DATE: 2011/01/07

REFERENCE:  
CLTH 1/2011/6

**MODEL : HILUX / FORTUNER (1KD & 2KD High Version Diesel Engines)**  
**SUBJECT : CLUTCH SHUDDER**

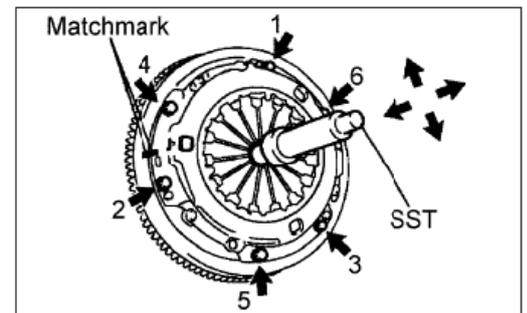
Investigation revealed that poor friction properties of the clutch disc material caused slippage between the flywheel and clutch cover. The slippage caused hot spots to occur on the flywheel and the clutch cover resulting in the shudder during pull-off.

TMC has introduced a new level clutch disc (part number: 31250-0k221) with an improved surface lining. The new level clutch disc reduces the slipping action during clutch engagement.

- Please clean the friction surfaces of the clutch cover and flywheel properly.
- Tighten the clutch cover bolts a little at a time in the correct sequence as per the picture above, starting at a dowel and finally torque the bolts to 24Nm.
- Use a transmission jack to refit the transmission to the vehicle.
- Please ensure that the clutch pedal is properly adjusted after replacement of the components.
